## **ADDENDUM No. 4**

### **Montello Street at Route 58 Re-alignment Project Carver, Massachusetts**

**August 17, 2021**

The following Addendum No. 4 is hereby issued to the Bid Documents entitled, “Montello Street at Route 58 Re-alignment,” dated July 21, 2021.

SCALE: N.T.S.

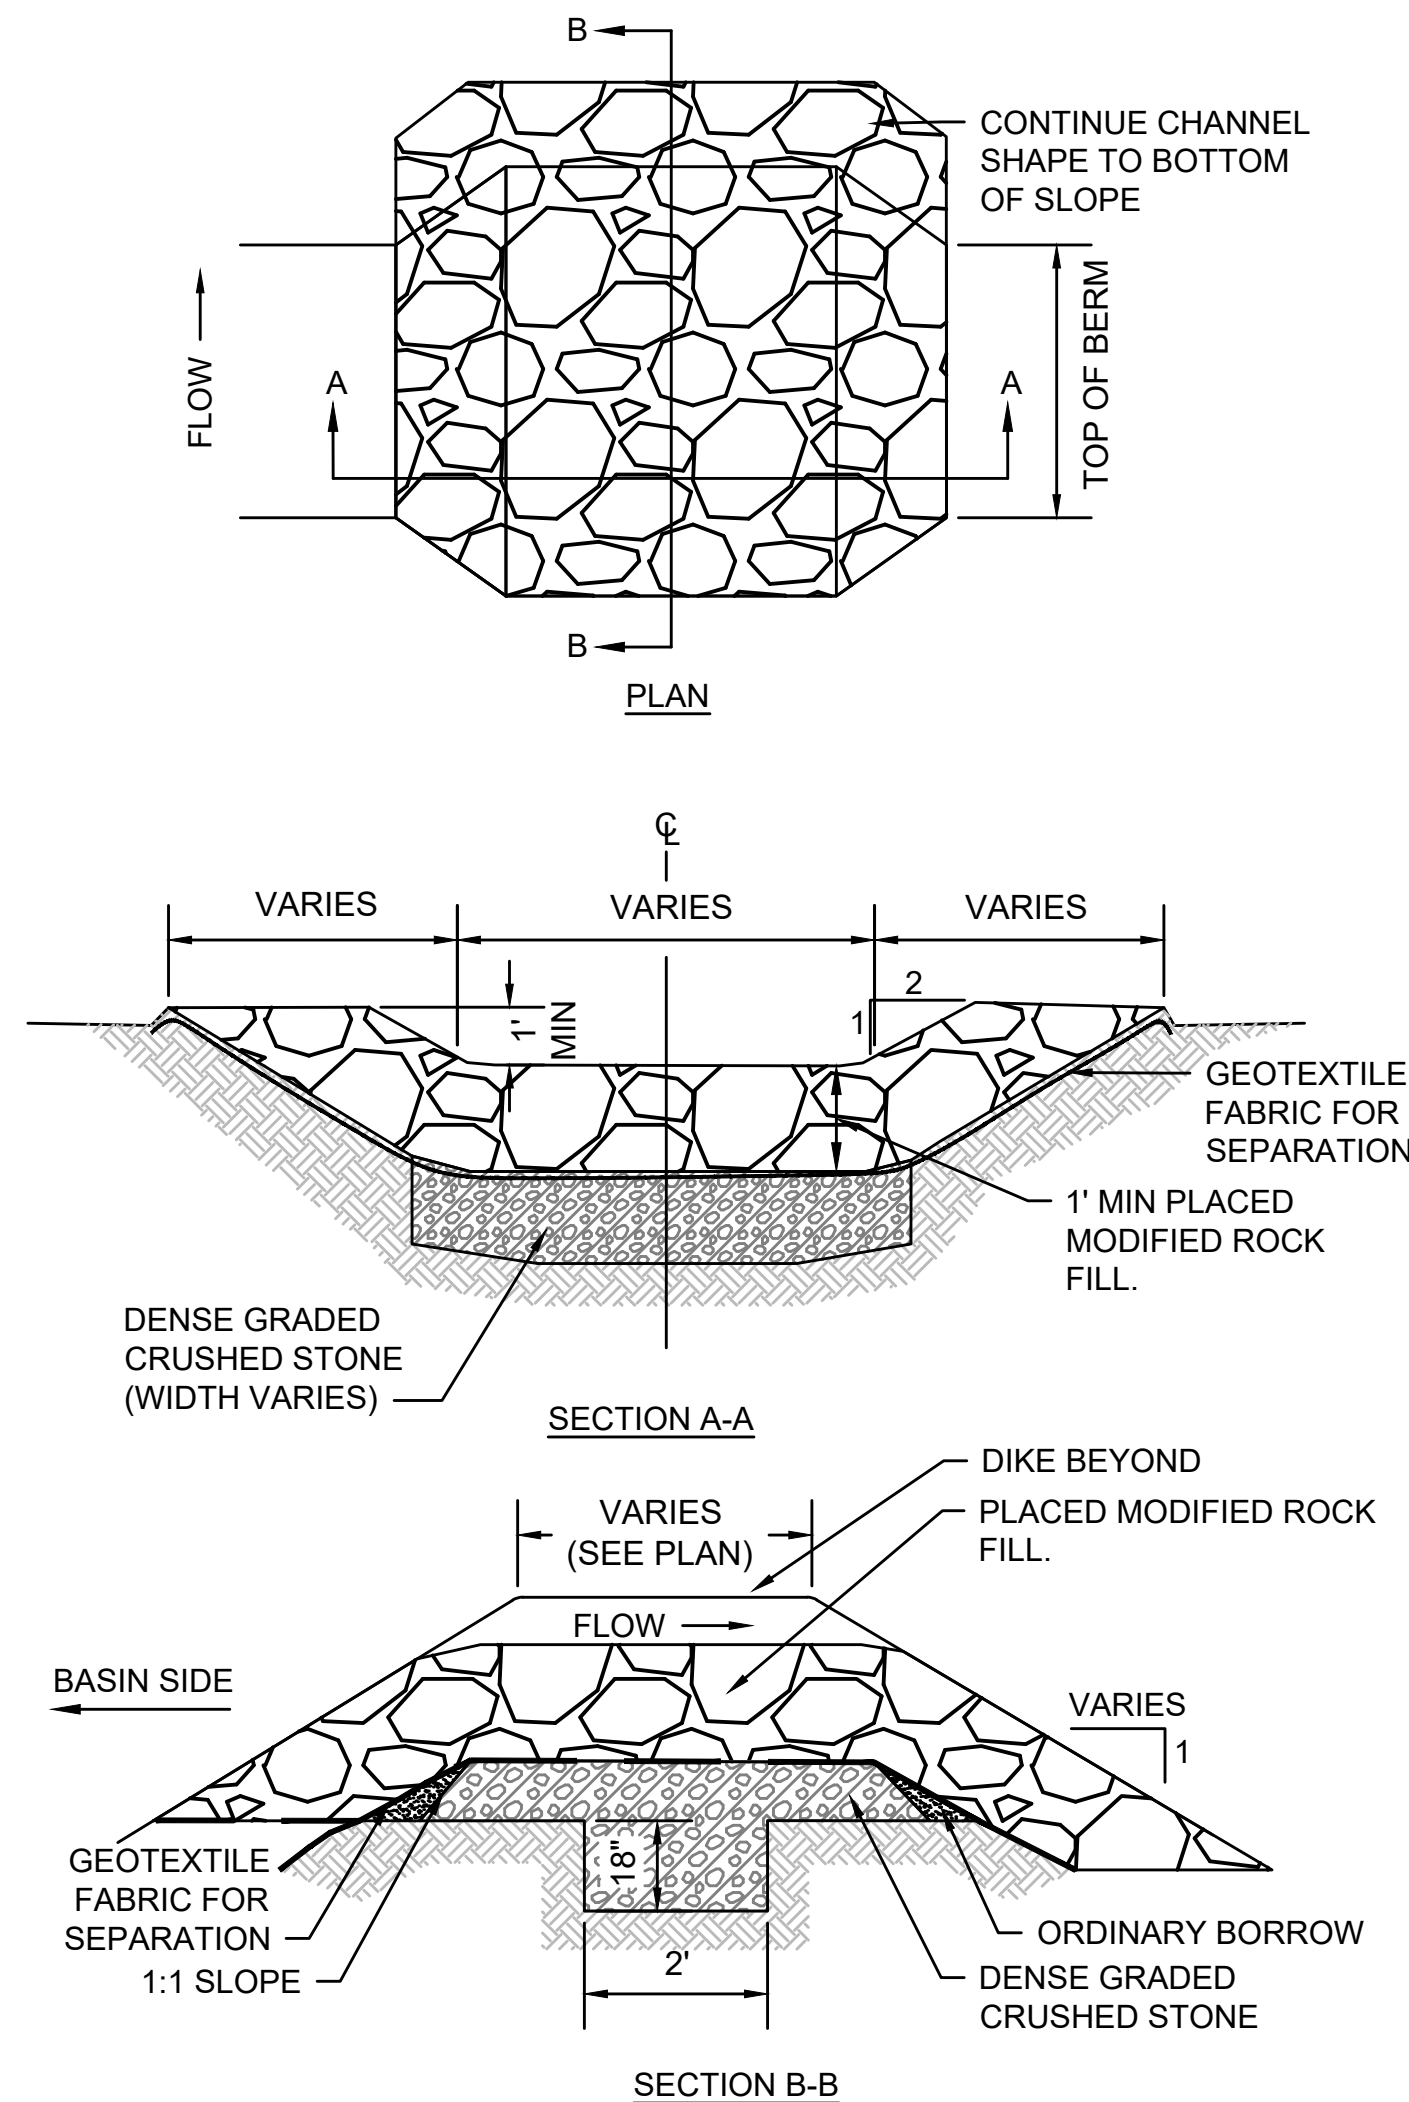
Q: The subdrain riser detail is showing ductile iron pipe and tee but the plans are showing PVC (solid and perforated) for this work. Please confirm the detail is wrong.

A: The detail shown in the plans is incorrect. **Bidders shall replace sheet 43 in the plans with the revised sheet 43, attached.**
